Project: Engineering, Procurement and Construction of the New Administrative Capital Monorail and 6th October City Monorail (Contract 93/Metro).

Subject: Non-conformities in Shop Drawings. // 93M-BOA-NAT-LOT-33659

93M-BOA-NAT-LOT-33659

2 Nos. FLANGE REQUIRED AS DRAWN MARKED B18

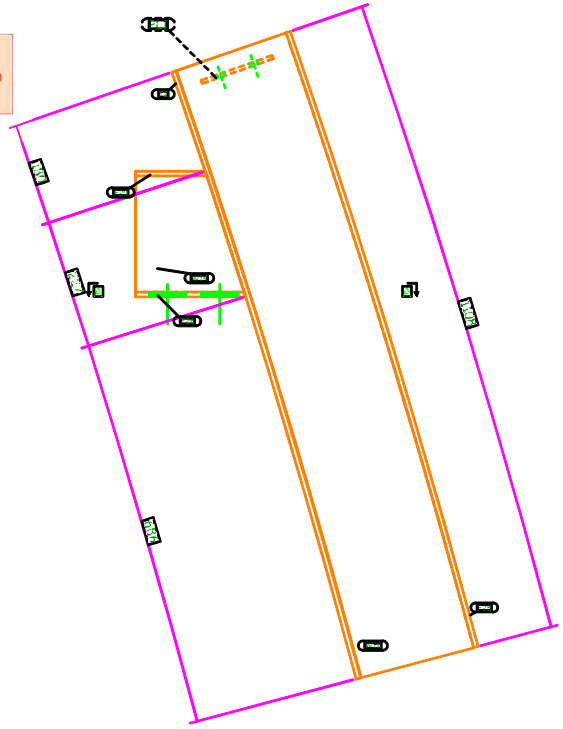
-Drawing shall be update according to the comments on the GA drawing.
-Approval is subject to approval of coordination package between multi-discipline

same comment as
39M-0407-ACC-6O11A-DWG-50023-A

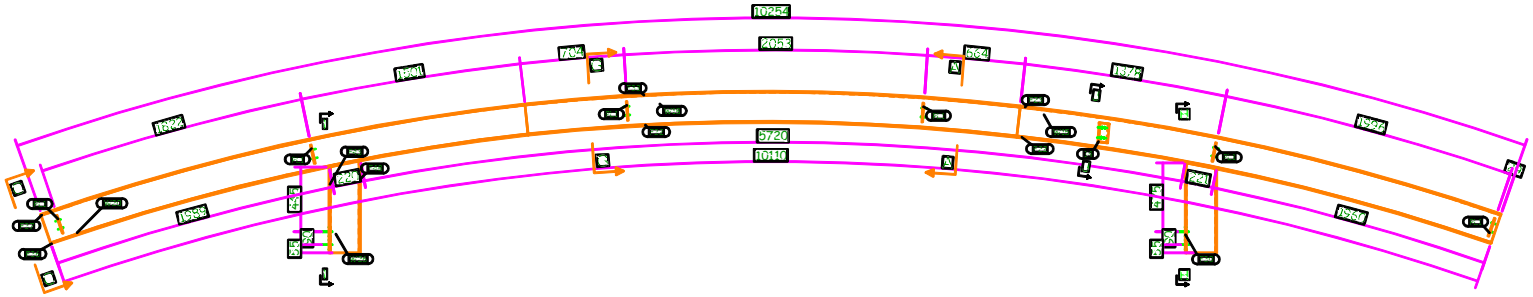
same comment as 39M-0407-ACC-6O11A-DWG-50023-A

-Drawing shall be update according to the comments on the GA drawing.
-Approval is subject to approval of coordination package between multi-discipline

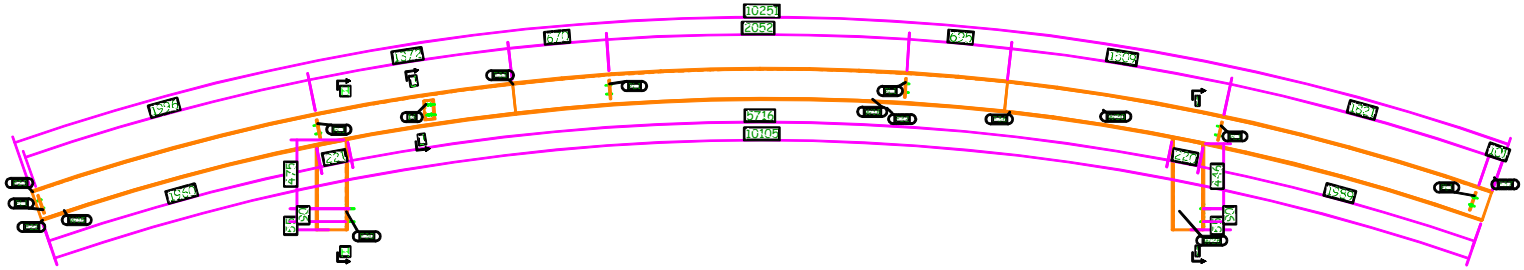
same comment as 39M-0407-ACC-6O11A-DWG-50023-A

-Drawing shall be update according to the comments on the GA drawing.
-Approval is subject to approval of coordination package between multi-discipline

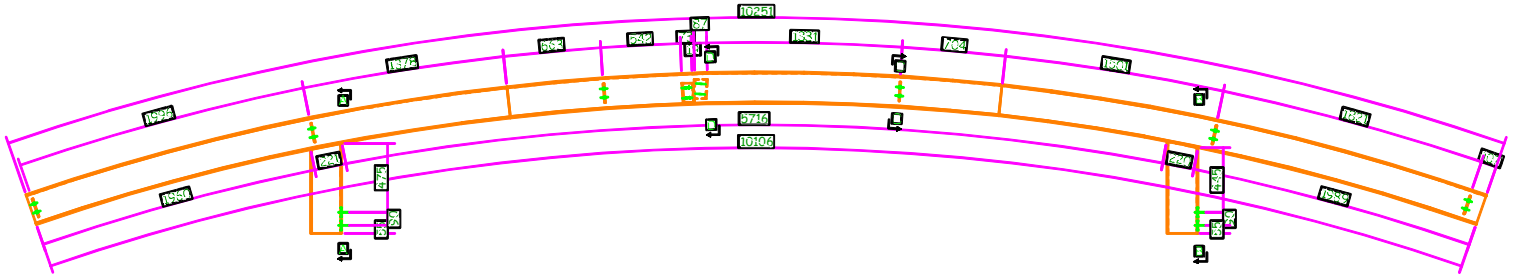
same comment as 39M-0407-ACC-6O11A-DWG-50023-A

-Drawing shall be update according to the comments on the GA drawing.
-Approval is subject to approval of coordination package between multi-discipline

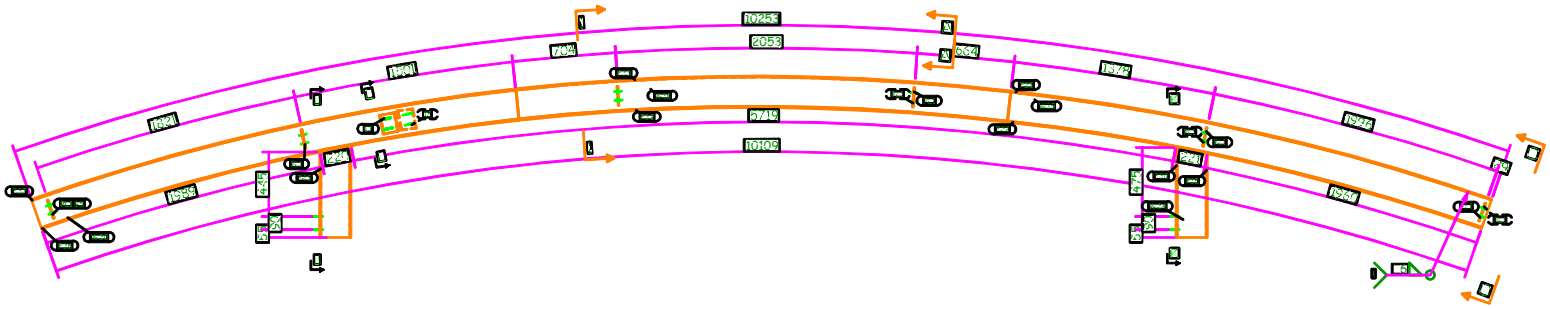
same comment as
39M-0407-ACC-6O11A-DWG-50023-A

-Drawing shall be update according to the comments on the GA drawing.
-Approval is subject to approval of coordination package between multi-discipline

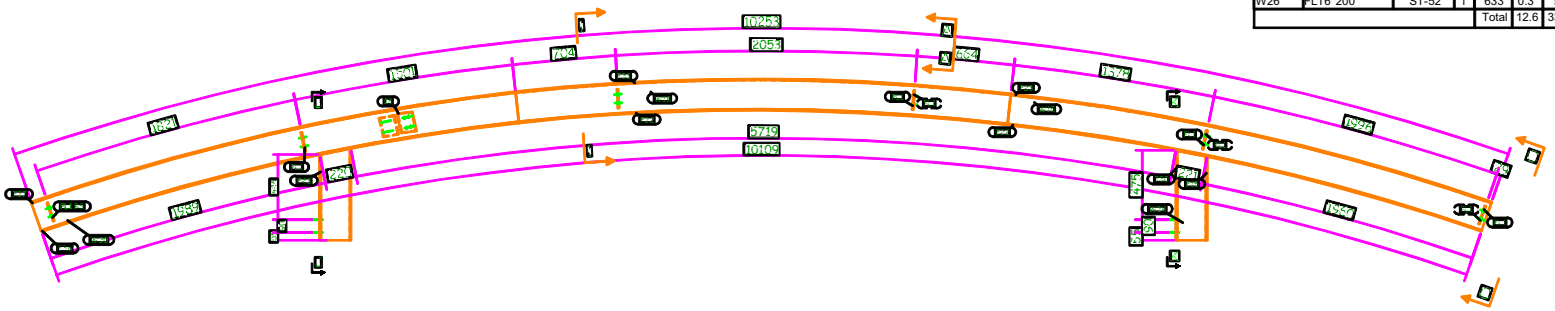
same comment as 39M-0407-ACC-6O11A-DWG-50023-A

-Drawing shall be update according to the comments on the GA drawing.
-Approval is subject to approval of coordination package between multi-discipline
